Ref. No. 201510024
Petition No. 517

PETITION NO. 517
 EXOTIC CARS
 14500 W. SEVEN MILE RD.
 DETROIT, MICHIGAN 48235
 C/O TONI KADA
 PHONE NO. 313 345-1000

**REQUEST BERM USE
 (For Parking Only)
 INTO STRATHMOOR AVE.
 AT 14500 W. SEVEN MILE RD.**

PETITION #0517

CITY OF DETROIT CITY ENGINEERING DEPARTMENT SURVEY BUREAU	
JOB NO.	01-01
DRWG. NO.	X 517

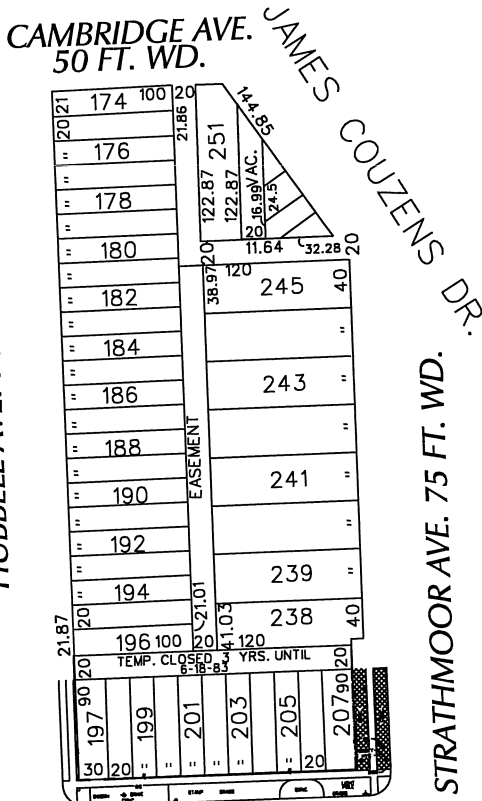
- (X) Traffic Engineering Division does not object to the request for berm use (for parking only) into Strathmoor Ave. at 14500 W. Seven Mile Rd as shown on attached drawing no. x517 dated 10/26/2015 and revised on 2/2/2016 provided that the following conditions are met:

1. This request is **approved only for parallel parking**, for up to five vehicles at a time keeping the required clearance from fire hydrant and Stop sign as indicated on attached drawing "Petition #0517" by Traffic Engineering Division, dated 2/2/2016, showing the layout of the berm parking. The berm use is allowed for employee parking only.

2. Requestor shall be responsible, at his/her expense, to install/maintain continuous concrete stoppers (painted yellow) for separation of vehicular and pedestrian usage as shown on the attached drawing "Petition #0517" by Traffic Engineering Division, dated 2/3/2016, showing the layout of the berm parking. It shall be the petitioner's responsibility to maintain at all times, a minimum 6 ft wide clear sidewalk in front of 14500 W. Seven Mile Rd.

B					
A	REVISED: REMOVING BERM PARKING REQUEST ON W. SEVEN MILE RD. AND THE WEST SIDE OF STRATHMOOR AVE.	WLW	KSM	KSM	2/2/16
DESCRIPTION		DRWN	CHKD	APPD	DATE
REVISIONS					
DRAWN BY	WLW	CHECKED			
DATE	10-26-15	APPROVED

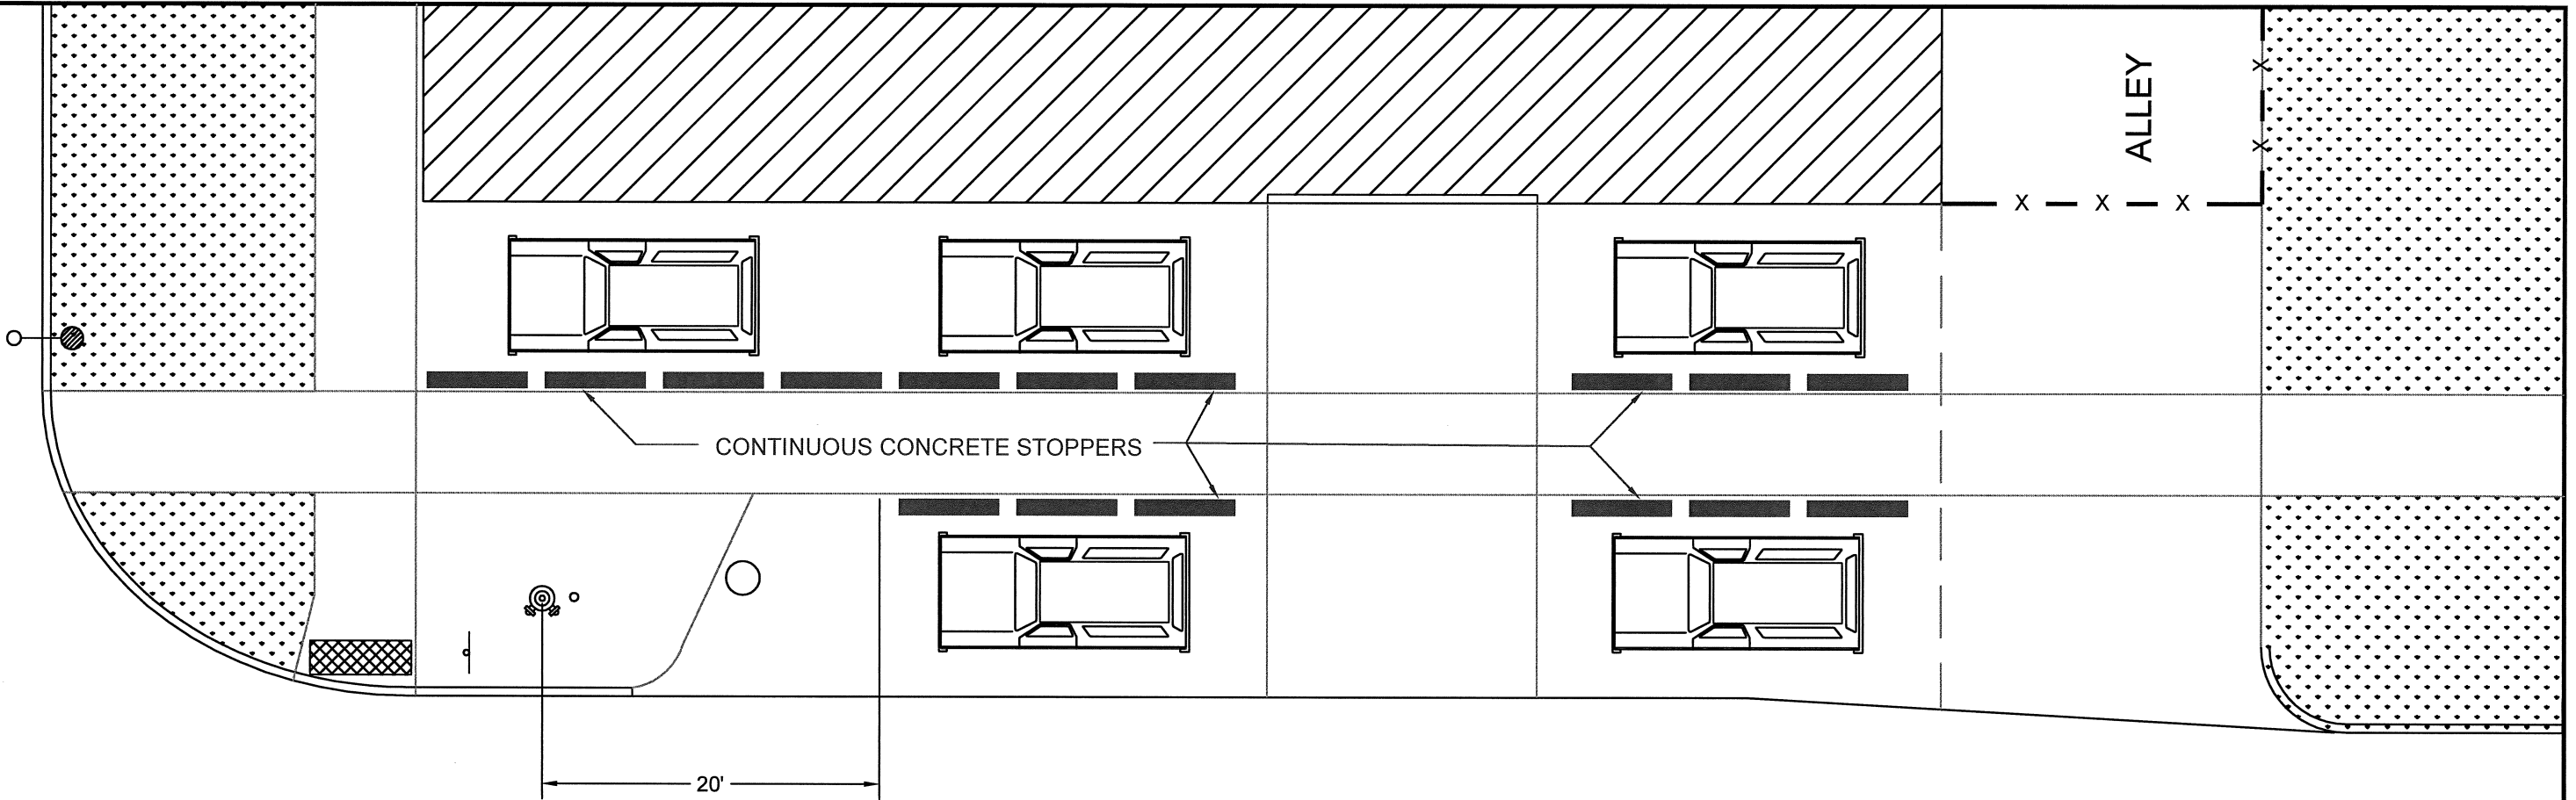
Traffic Engineering Division does not object to the request for berm use (for parking only) into Strathmoor Ave. at 14500 W. Seven Mile Rd as shown on attached drawing no. x517 dated 10/26/2015 and revised on 2/2/2016 provided that the following conditions are met:

1. This request is approved only for parallel parking, for up to five vehicles at a time keeping the required clearance from fire hydrant and Stop sign as indicated on attached drawing "Petition #0517" by Traffic Engineering Division, dated 2/2/2016, showing the layout of the berm parking. The berm use is allowed for employee parking only.

2. Requestor shall be responsible, at his/her expense, to install/maintain continuous concrete stoppers (painted yellow) for separation of vehicular and pedestrian usage as shown on the attached drawing "Petition #0517" by Traffic Engineering Division, dated 2/3/2016, showing the layout of the berm parking. It shall be the petitioner's responsibility to maintain at all times, a minimum 6 ft wide clear sidewalk in front of 14500 W. Seven Mile Rd.

3. Requestor shall be responsible for maintaining the berm surface and removal of snow from the berm area, at his/her expense.
4. City reserves the right to revoke the approval of berm parking if it is determined to be in the best interest of the City of Detroit or in case of requestor's failure to comply with the terms and conditions stipulated in the approval of the berm parking.
